REMARKS

Version with Markings to Show Changes Made

FIG. 4

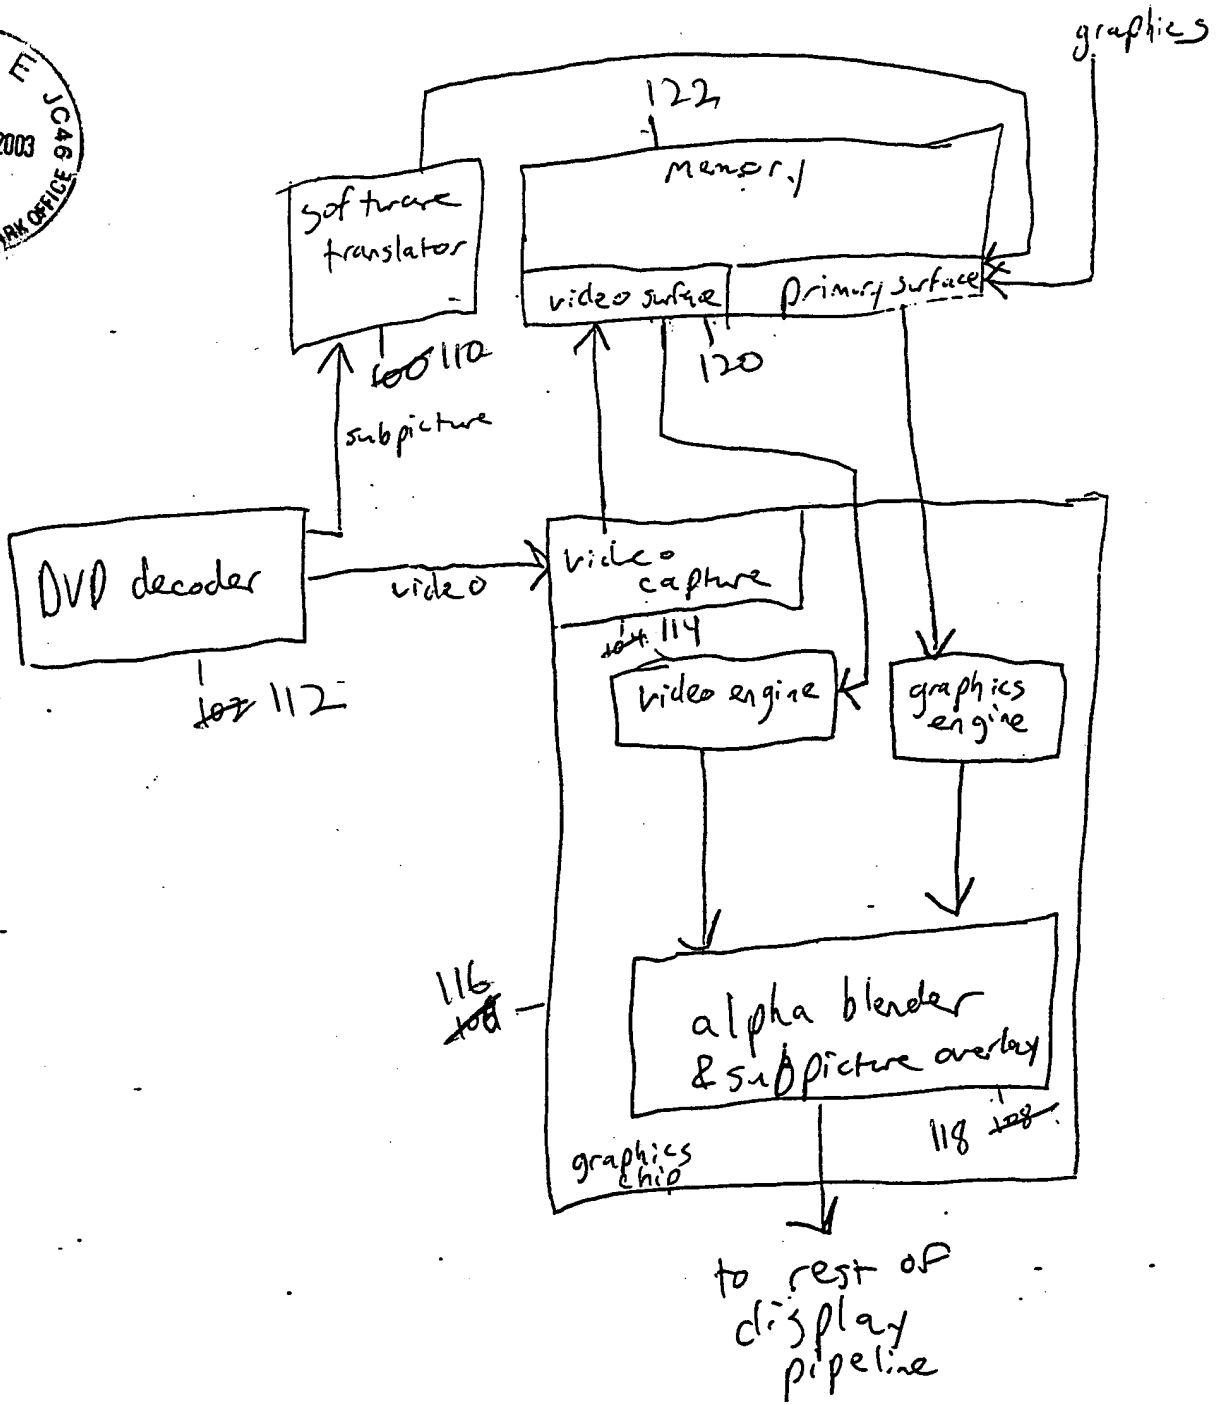
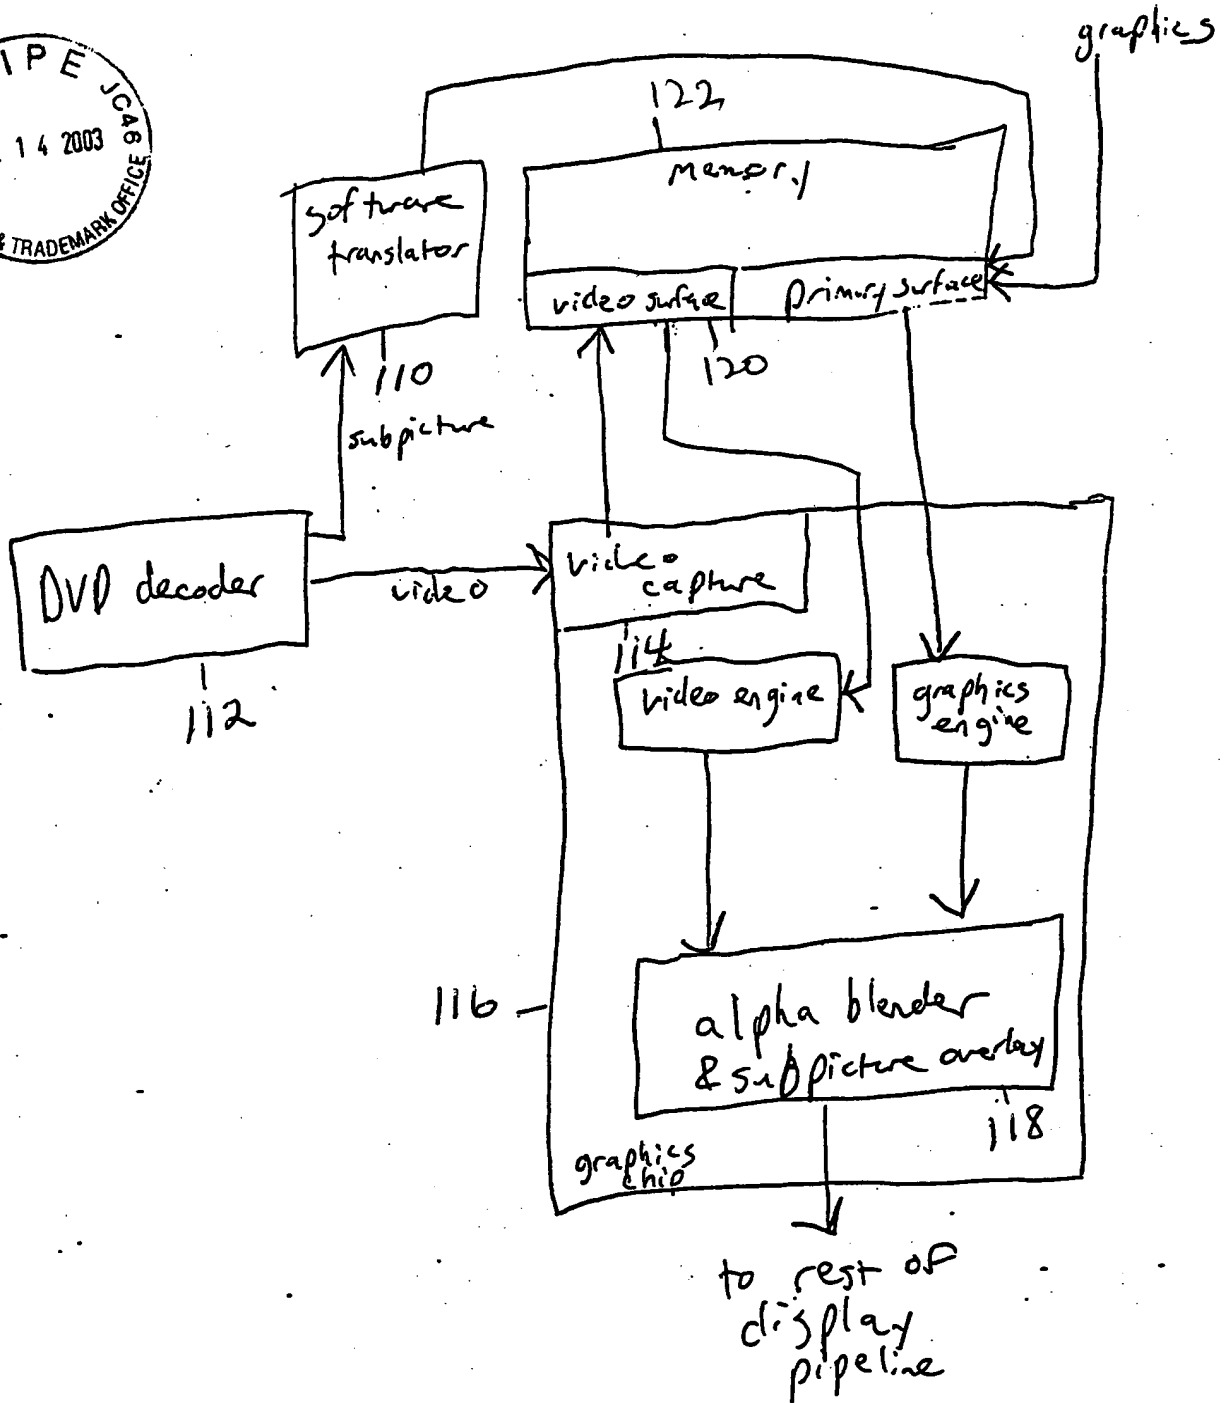
FIG. 4 is a block diagram illustrating the organization of a presently preferred embodiment of the present invention. A software translator [100] 110 receives subpicture information from a software DVD decoder [102] 112, while video information is sent to video surface [110] 120 in memory [112] 122. DVD decoder [102] 112 would likely have been designed to combine separate video and subpicture streams since DVDs are encoded with separate streams, so separating out or requesting that the separate streams not be combined in the first place should not present a problem. To the extent that it does, however, an additional module may have to be placed after the DVD decoder [102] 112 to separate out the subpicture and video streams. The present invention also assumes that the subpicture information received by the software translator [100] 110 is in the standard 4:4 format. To the extent that it is not, it must be translated into that format.
